## **REWORK FIELD SERVICE BULLETIN**

FSB Number	CHRAEFSB2016-34
Author	Tony Bryan
Date	12/05/2016
Subject	Moto Z, Moto Z Droid - Battery Swell
Model Affected	XT1650-01, XT1650-03, XT1650-05
Level Of Repairs	Level 2

**Figure 2.0 - Kapton Tape Placement**

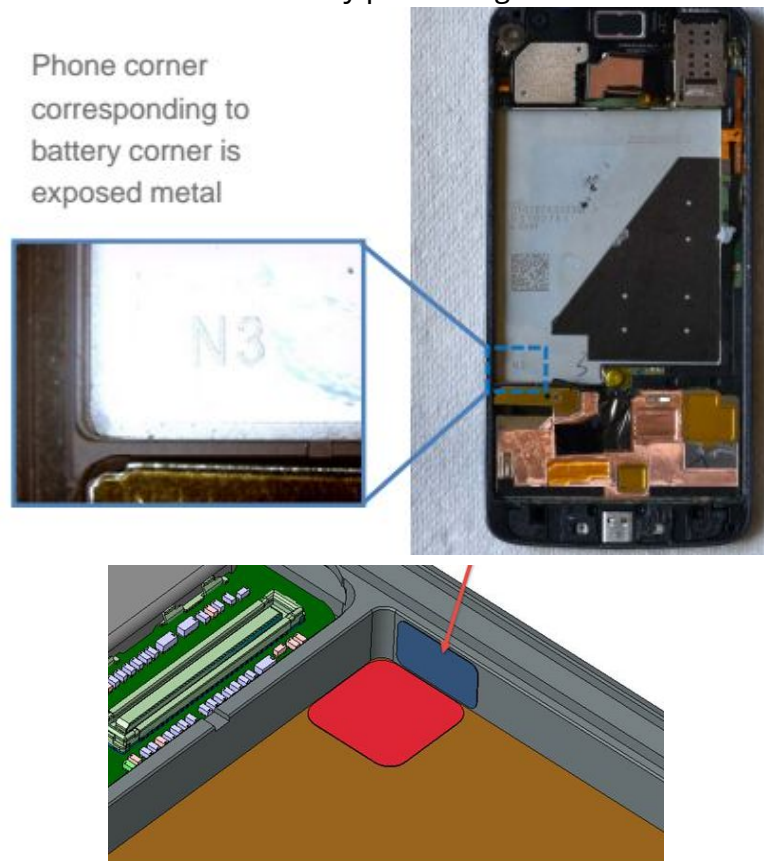
1. Motorola optimized the battery assembly method to align the battery pack along the right side of the pocket to avoid contact with housing along left side.
2. Motorola has implemented the placement of two pieces of kapton tape in the affected bottom left corner of the housing battery pocket to isolate the battery pack from the metal housing. See Figure 2.0 below for placement.
  - a. Tape #1 - 5.75mm x 5.75mm Kapton Tape (p/n: 11018063002) placed flat in bottom left corner of battery pocket aligned with corner edges.
  - b. Tape #2 = 5.0mm x 2.75mm Kapton Tape (p/n: 1105063003) placed along bottom left side of the battery pocket aligned with corner edge

1. If not already placed, place the two pieces of Kapton Tape in bottom left corner of housing battery pocket to isolate the battery pack from the metal housing. Reference Figure 2.0 above for details on placement.
  - a. Tape #1 - 5.75mm x 5.75mm Kapton Tape (p/n: 11018063002) placed flat in bottom left corner of battery pocket aligned with corner edges.
  - b. Tape #2 = 5.0mm x 2.75mm Kapton Tape (p/n: 1105063003) placed along bottom left side of the battery pocket aligned with corner edge
2. Place GV30 Battery Pack (p/n: SNN5972A) making sure to align the battery pack along the right side of the pocket and avoid contact with housing along left side.
3. Following the Service Manual document, complete reassembly.
4. Per normal service procedures, completely retest to ensure proper repair.

**Figure 3.0 - Battery Insulator Change**

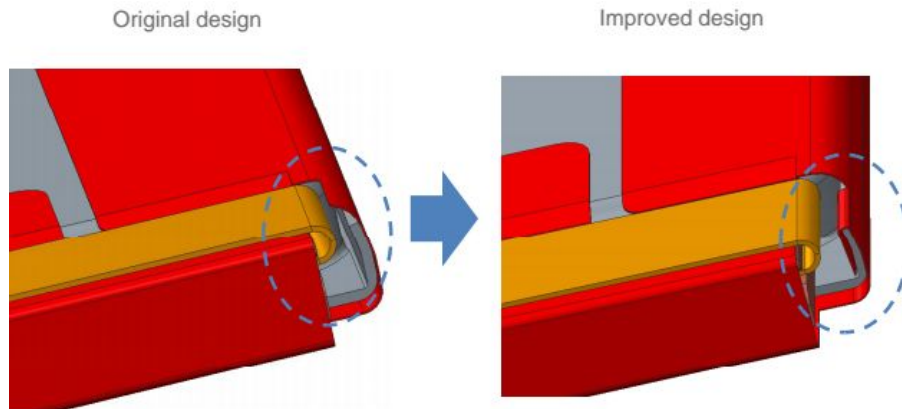
The battery supplier will increase the size of the battery insulator to better protect the corner of the pack. See Figure 3.0 below for details. This will be a running change to the existing GV30 Battery Pack (p/n: SNN5972A).

**NOTE:** The Short-Term Solution (Kapton Tape Placement), although not required, can be combined with the Long-Term Solution (Battery Insulator Change).
